Your Ref: SSD-8636-Mod-2
Our Ref: R/2018/7/C
File No: 2020/309337

New Request for Advice – University of Sydney – Engineering & Technology Precinct – SSD 8636 Modification 2

Figure 5 1% AEP Flood Depth Afflux (Proposed - Existing)

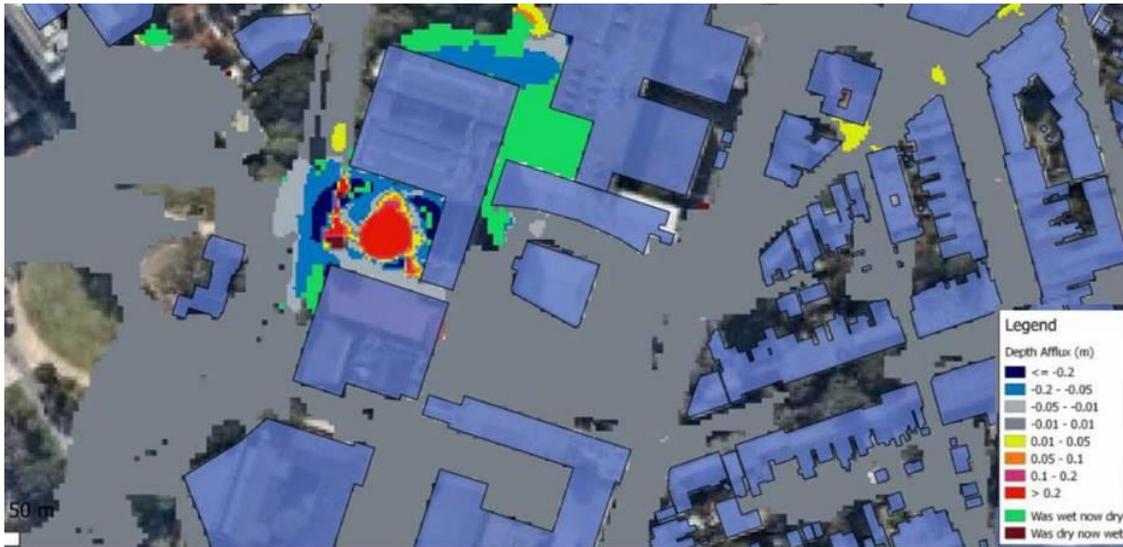
- **Condition B37** – Section 4.1 of the submitted SJB Planning Report states the request for deletion of Clause 37 is supported by additional flood modelling “which indicates that the development does not result in an increase in flood affectation for the existing Electrical Engineering Building”. However, Figure 5 (shown below) of the of the Flood Investigation – Basin D Removal report, shows a significant increase in flood depth (shown red) just outside the building. The City seeks clarification on this.

There is insufficient information provided at this stage to determine if the City can support the removal of this condition. Section 3.1, paragraph 2 of the Flood Investigation – Basin D Removal report, notes that this basin was for the purpose of both flood mitigation and water quality treatment. It is noted that the On Site Detention (OSD) being proposed as an alternative is to include bio-retention for water quality treatment. It is therefore possible that this alternative is acceptable but there is insufficient information given to conclude if it is capable of the same performance of the previously proposed basin.
